Re: ***1236 George Bush Boulevard, Delray Beach, Florida ("Property")
Class V Site Plan Application ("Application")
Request for Waiver (L.D.R. Section 2.4.7(B))***

The undersigned represents 1236 George Bush Blvd, LLC, the owner and applicant for the referenced Class V. This letter shall serve as a summary of the justification for the Application's waiver request pertaining to the TAC ID-1079, new 3rd review, comment 31 which references the following horizontal offset requirement as established in the Florida Greenbook ("Offset Requirement"):

ROADWAY PLAN

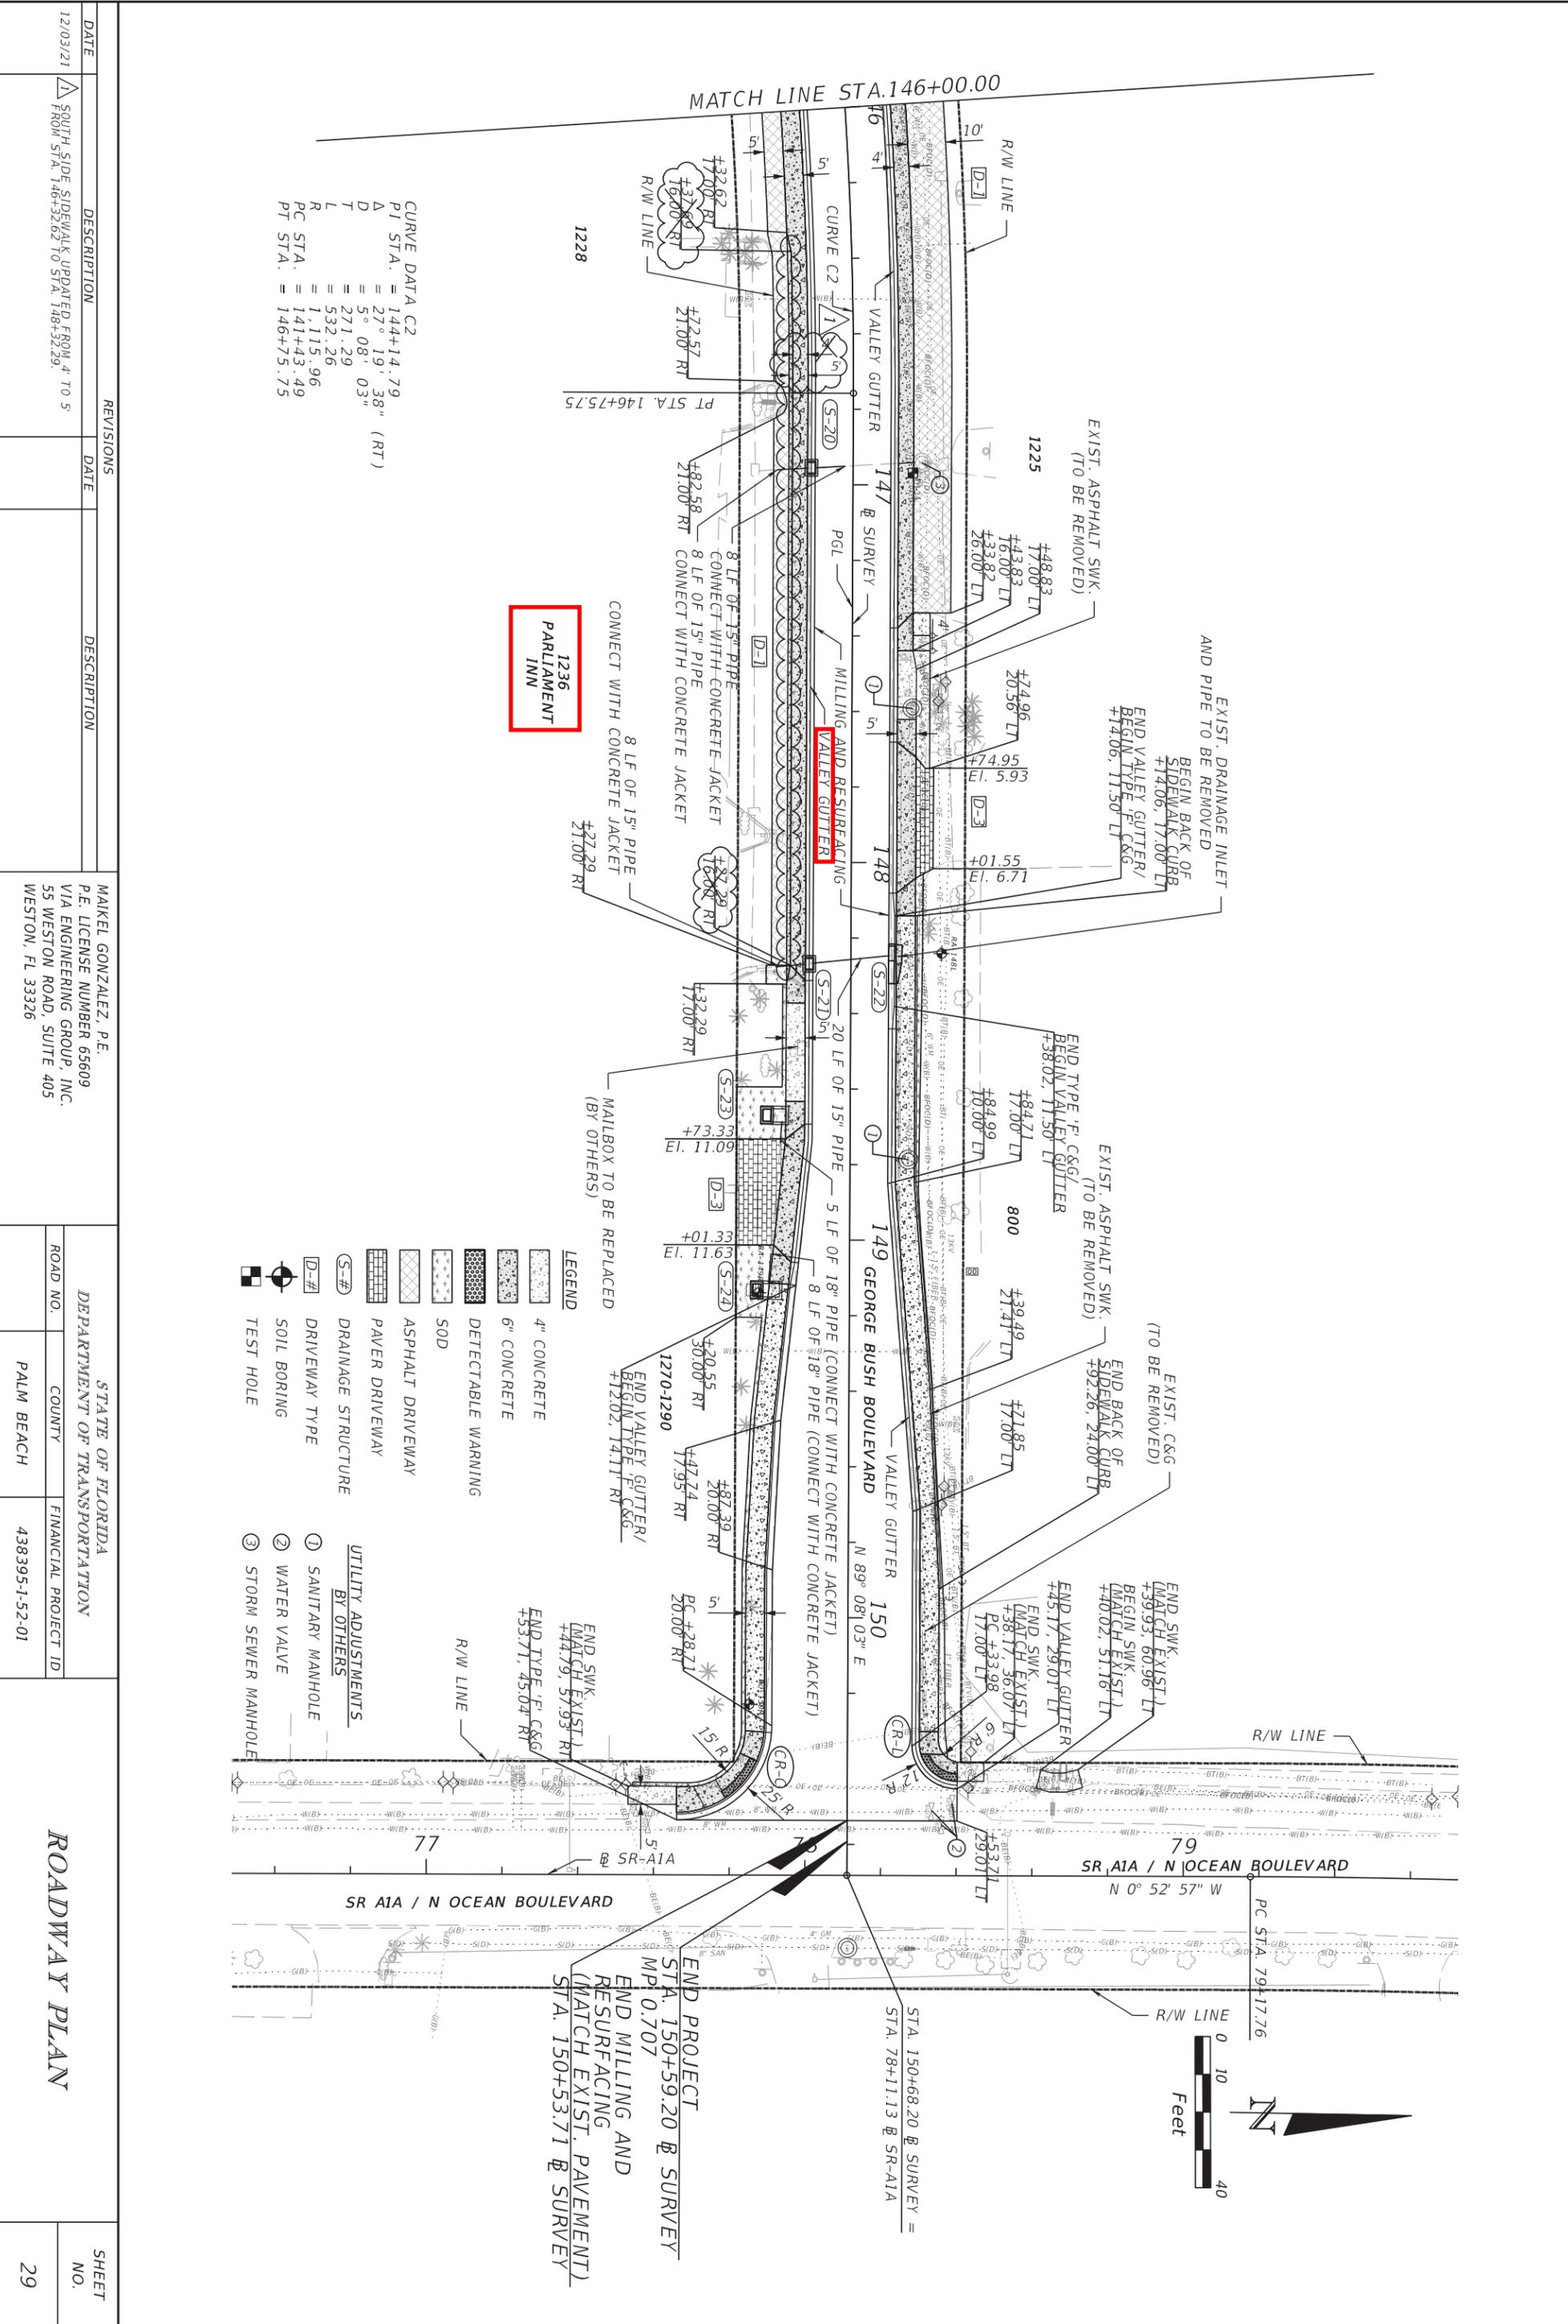
31. Please adjust the street trees to be at least 14' from the edge of traveled way or provide raised curbs to adjust the required offset to 4' from face of curb to comply with horizontal offset requirements as established in the Florida Greenbook.

At the proposed alternative 4' offset, the installation of an F or D curb would be necessary to comply with the requirements of the FDOT Greenbook. An F or D curb, however, would conflict with the current FDOT Roadway Plan (Exhibit A), providing for a valley gutter. The installation of an F or D curb would further interfere with ingress and egress from the residences. As shown on the Site Plan, there are to be six (6) driveways along the frontage of the Property. An F or D curb cannot be placed within any of the driveways, requiring a valley gutter for vehicular access. Even assuming some allowance by FDOT for an F or D curb at the location (which has not been provided) such a modification would be highly impractical resulting in only a very minimal percentage of the frontage to provide for the raised curb, rendering the placement and location of the trees meaningless to the intent of the applicable landscape regulation purpose.

Waiver Request re: Omit requirement of additional trees within the frontage of the Property and at 4' or 14' from the face of the curb in accordance with the Offset requirement and L.D.R. Section 4.6.16.
